# Comments on SAS2r14 Physical Layer

**Kevin Witt**  
**March 27, 2008**  
**08-144r2**

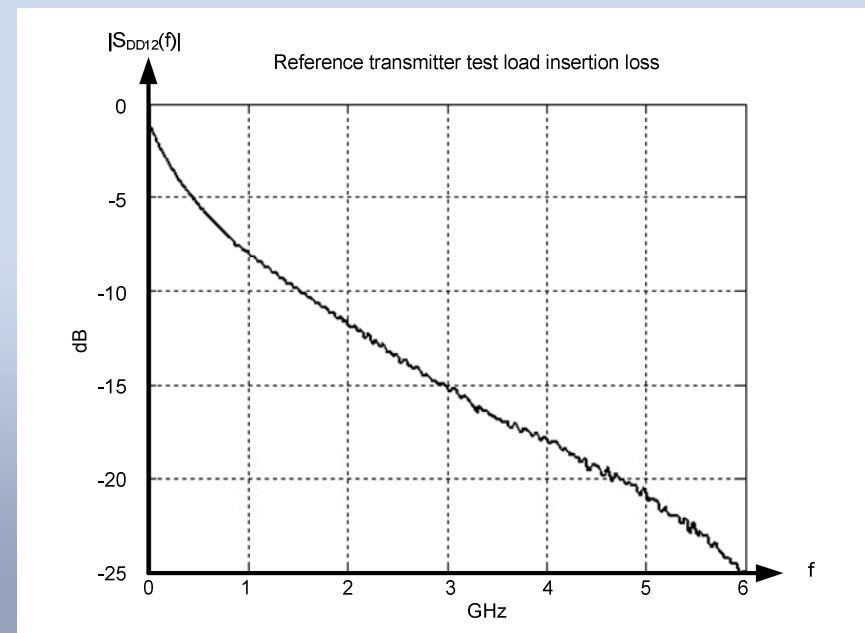
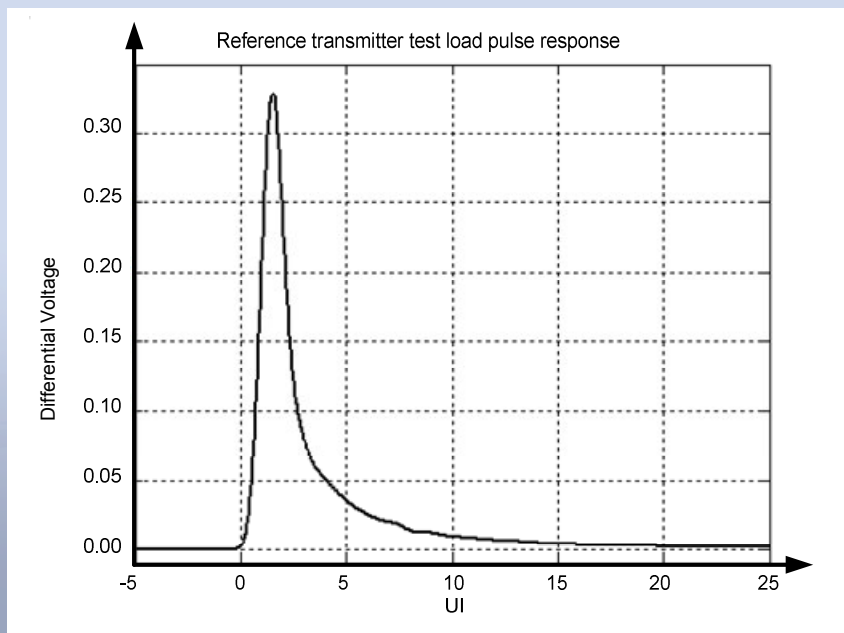
- Page 203: DFE Equation inconsistent with description.
  - Fix index of summation for  $i=1$  to 3
- Page 179:
  - Add pulse response figure (Clean Ref Tx) and Insertion loss plots

### — Page 205:

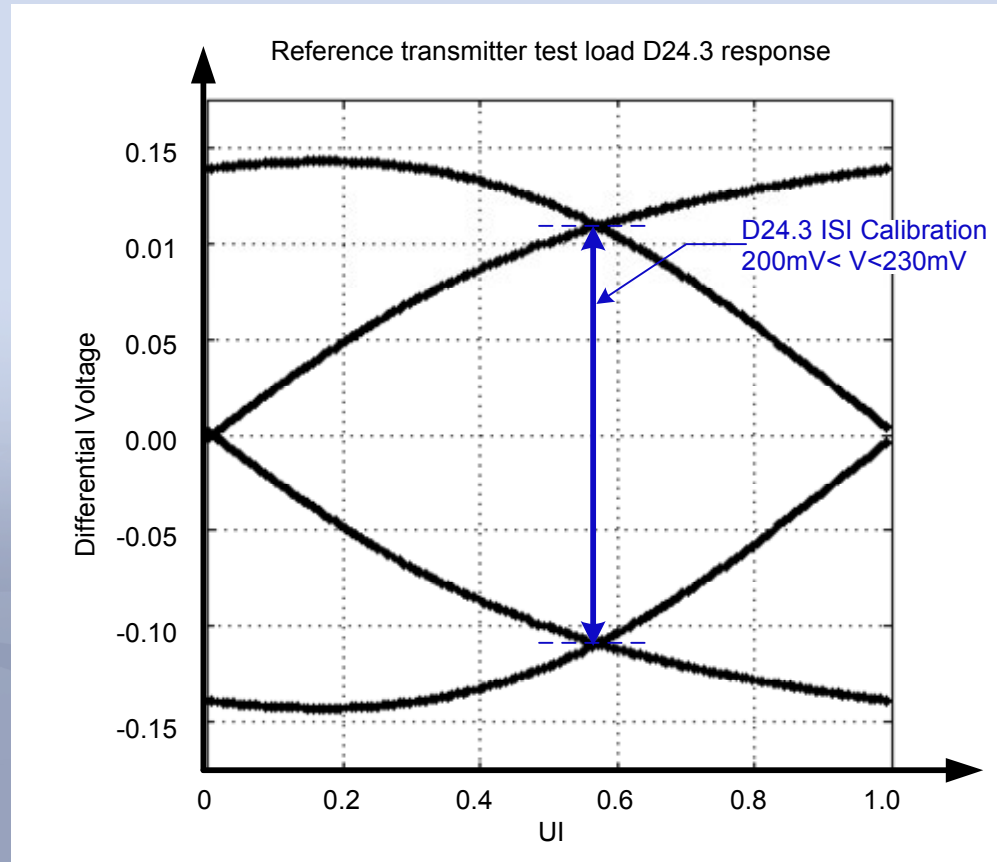
- Add D24.3 response graphic
- Change the voltage specification to
- “The difference of the “1” level centroid at the crossing, determined with a vertical histogram, minus the “0” level centroid at the crossing, also determined with a vertical histogram.

Figure 131 — Stressed receiver sensitivity test block diagram

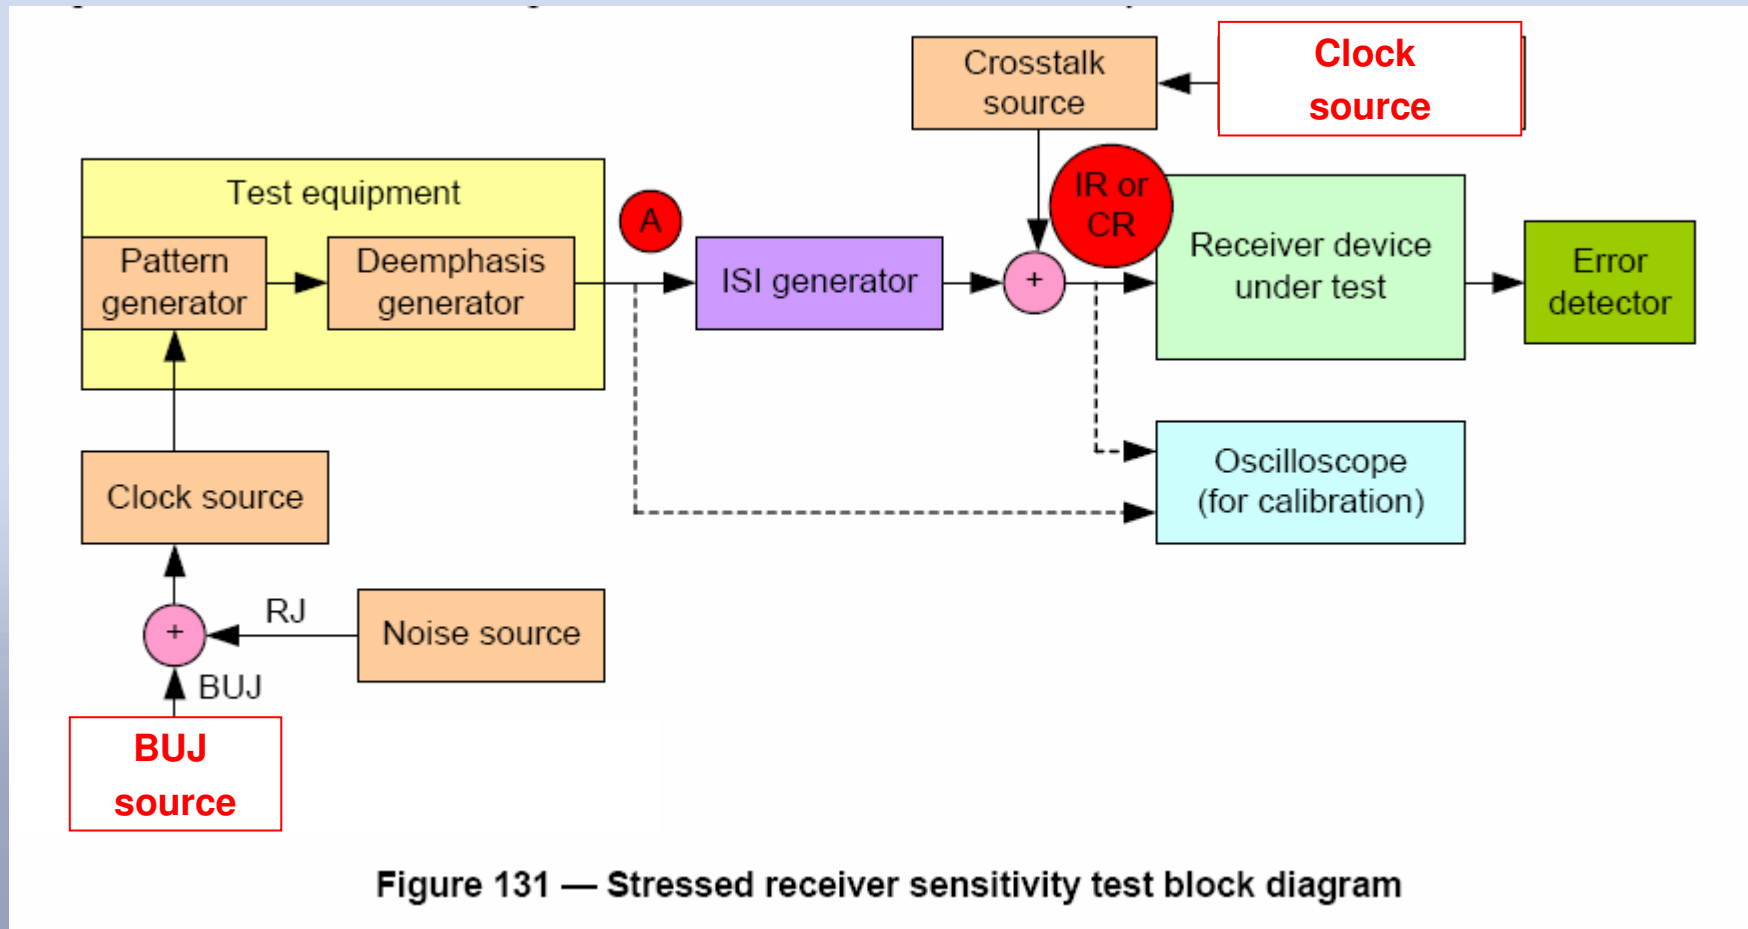
## Proposed Change to Figure 131

- Remove BUJ details

**Figure 132 Jitter tolerance test block diagram**

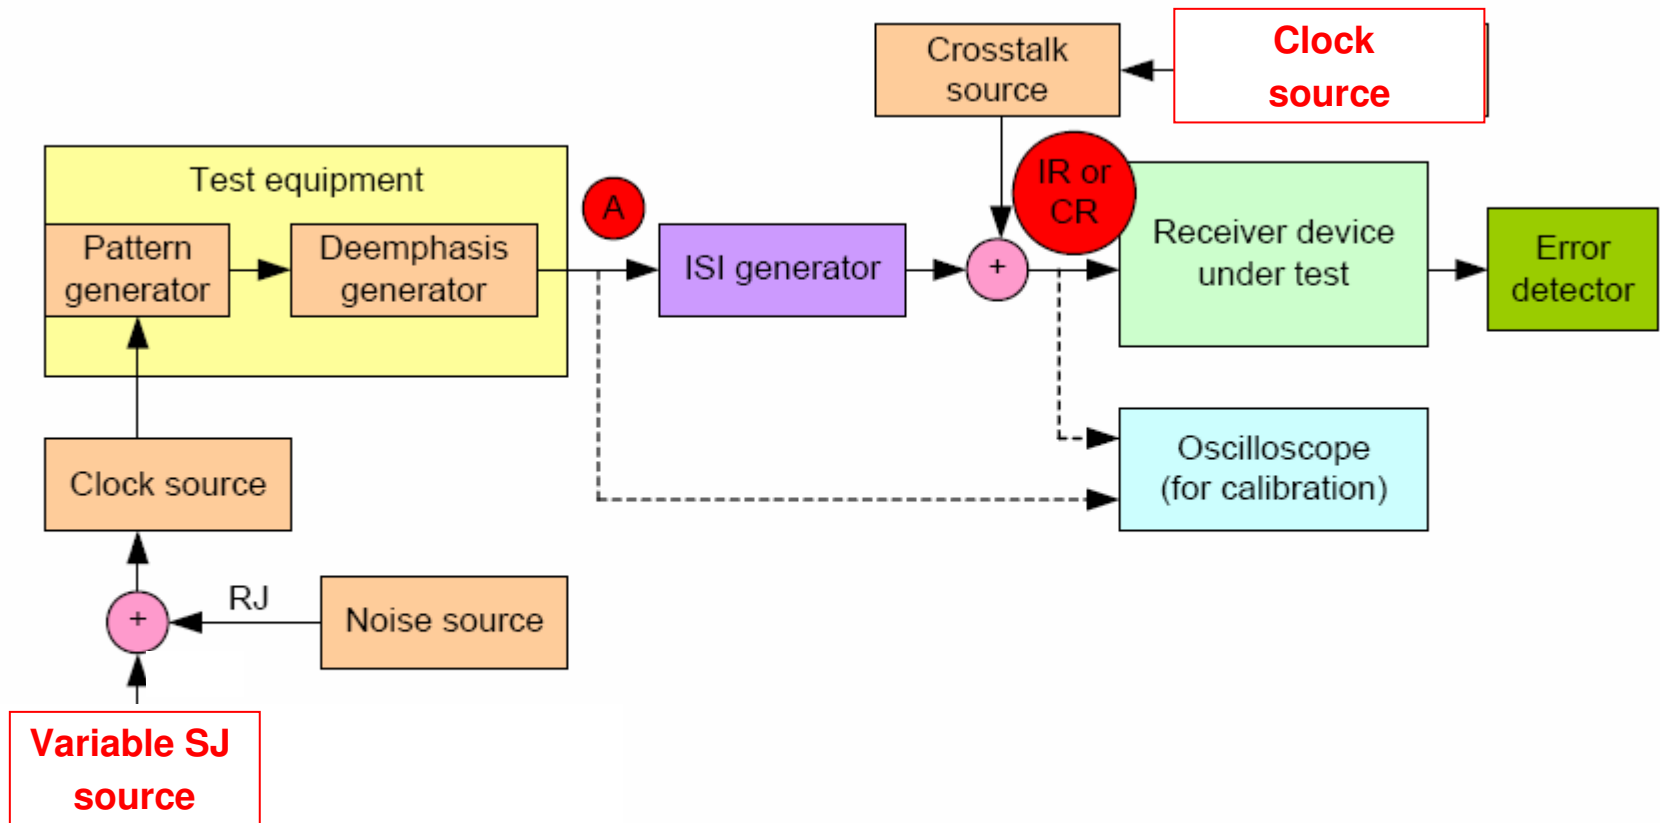
A receiver device shall satisfy the jitter tolerance test described in this subclause. The jitter tolerance test leverages the receiver device physical test hardware. The receiver device under test shall demonstrate a BER that is less than  $10^{-12}$  with a 95 % confidence level when subjected to the sinusoidal jitter ~~defined in 6.6.7.6.~~  
**in Figure 122 as illustrated in Figure 132.**

- **Figure 122 Update**

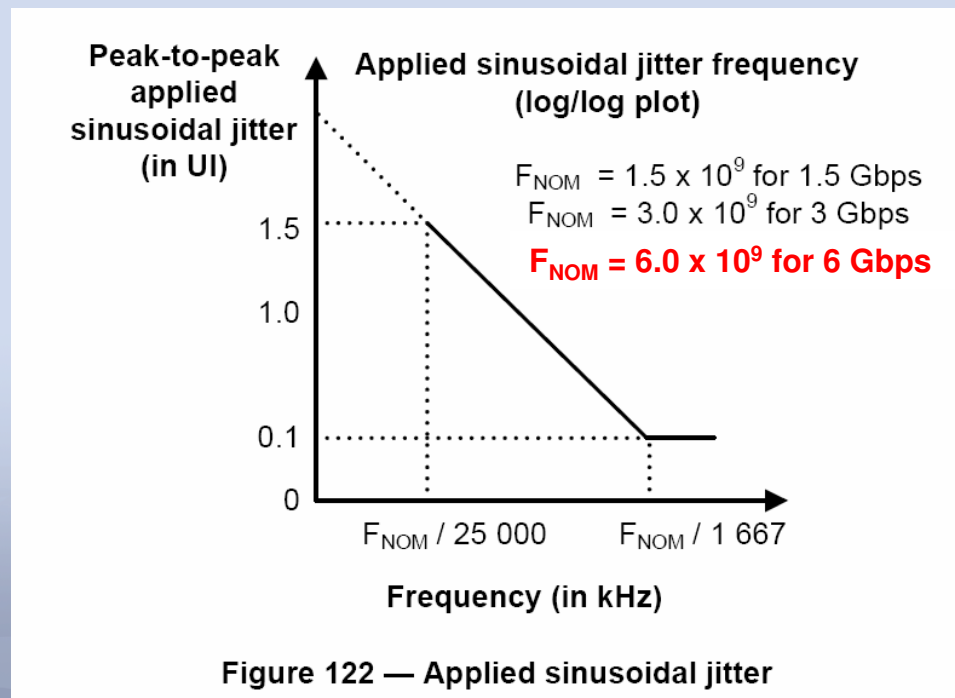
## Proposed Change to 5.3.7.4.4.7

## Summary of Proposed Calibration

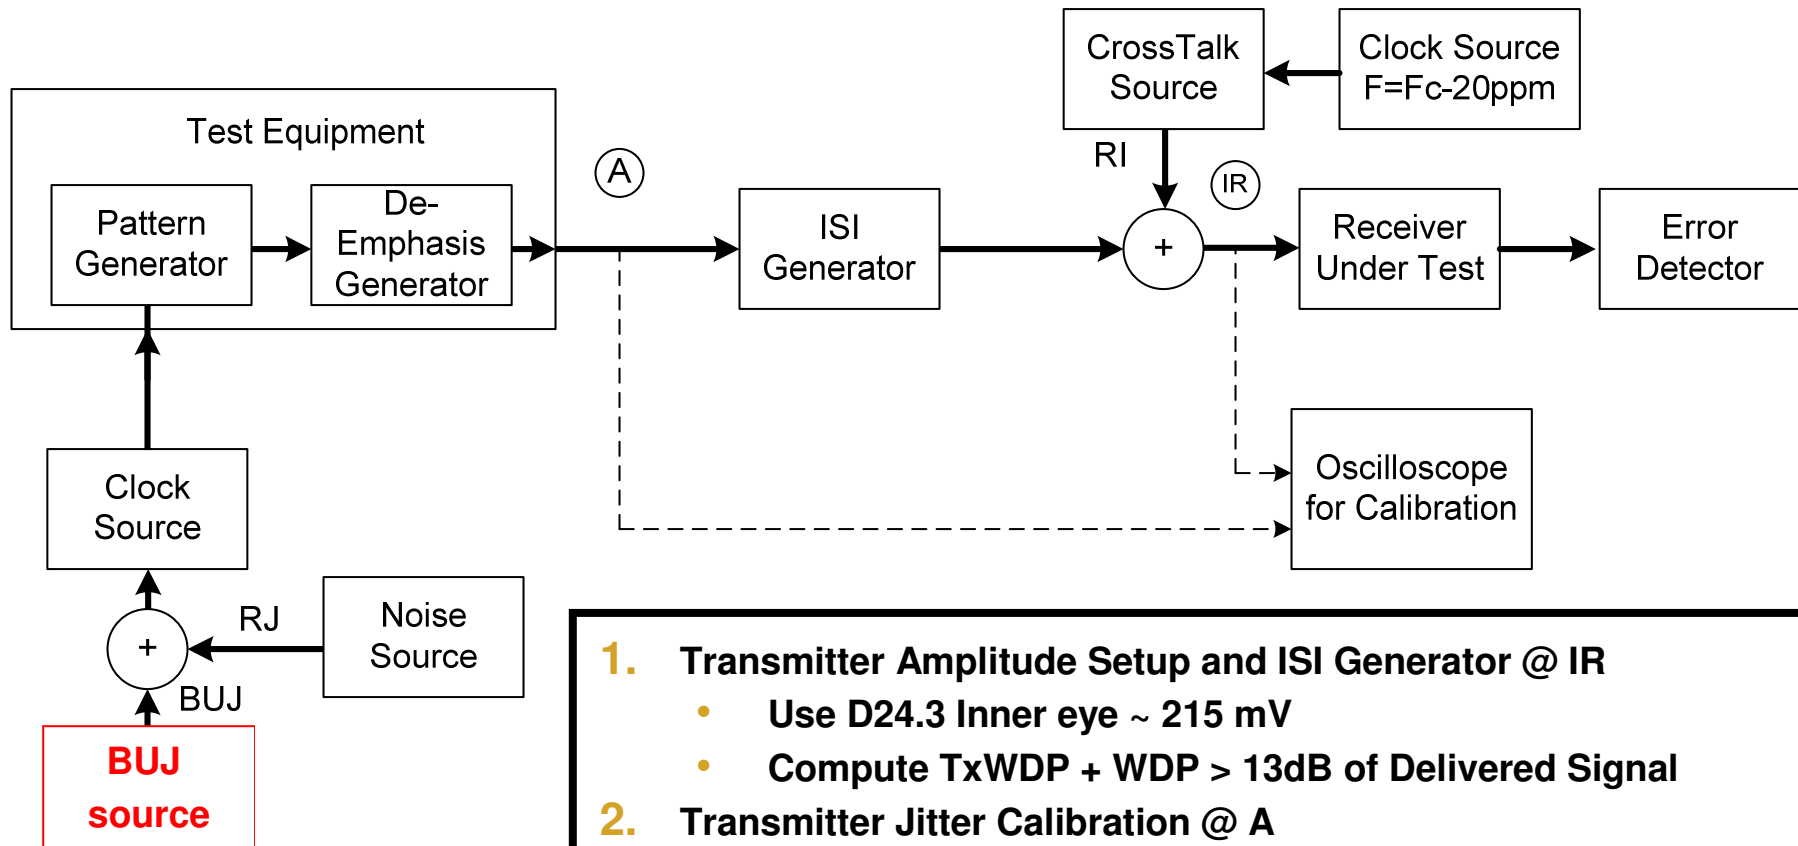
- 1. Transmitter Amplitude Setup and ISI Generator @ IR**
  - Use D24.3 Inner eye ~ 215 mV
  - Compute TxWDP + WDP > 13dB of Delivered Signal
- 2. Transmitter Jitter Calibration @ A**
  - Adjust RJ = 0.15 UI pk-pk
  - Adjust BUJ = 0.1 UI pk-pk
- 3. Crosstalk @ IR**
  - PRBS-7 Crosstalk Source and Adjust Coupled Amplitude > 4mV rms
- 4. Test – Confirm BER < 1e-12**

## Calibration Procedure Illustrated

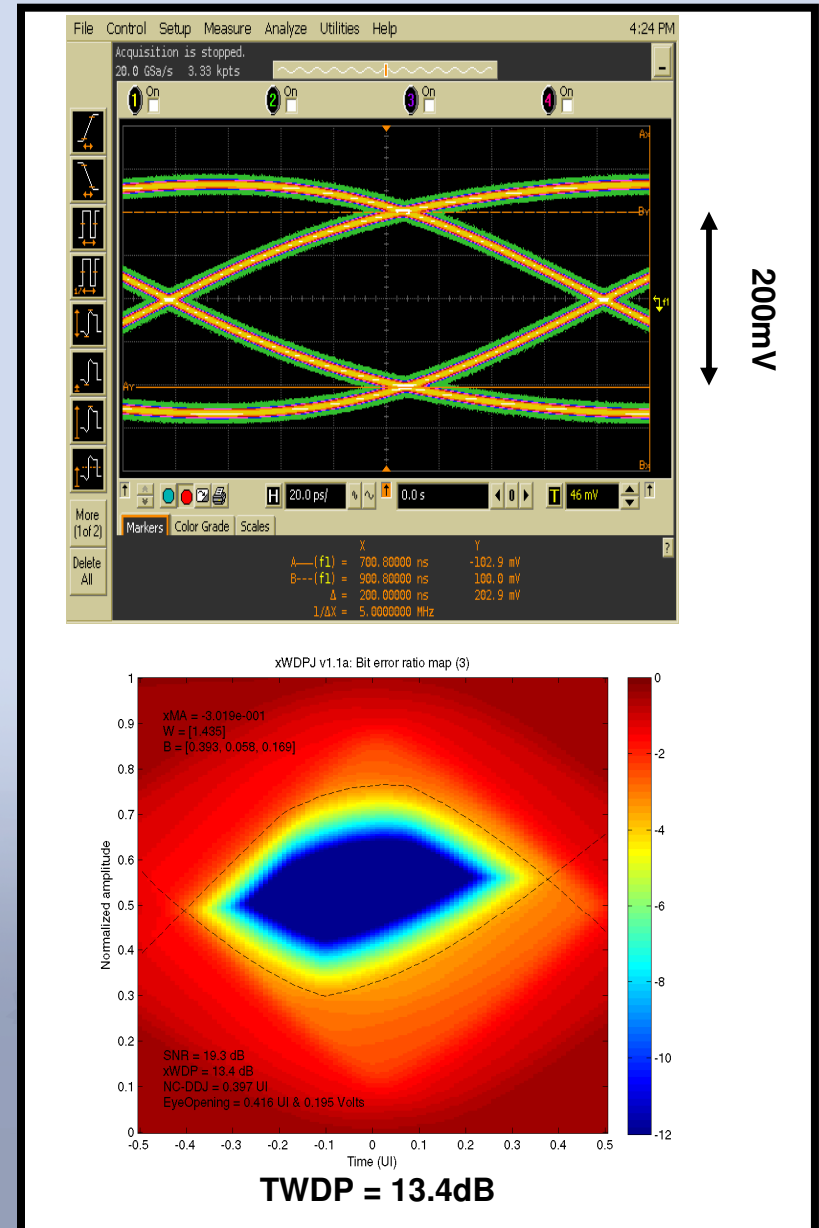
1. Measure Inner Eye with D24.3
  - Without jitter or Crosstalk
2. Compute WDP of Delivered Signal with SAS CJTPAT for the budgeted PALLOC of 15.4.
  - Make sure  $> 13.0$  dB
3. Setup Tx Jitter with Standard Test Equipment Options.
  - $RJ = 0.15UI$
  - $BUJ = 0.1UI$
4. Setup Additional Cross talk as needed to meet NEXT limit.
  - Turn on all channels, add crosstalk for a total of 4mV RMS
5. Confirm DUT BER  $< 1e-12$  @ 95% confidence
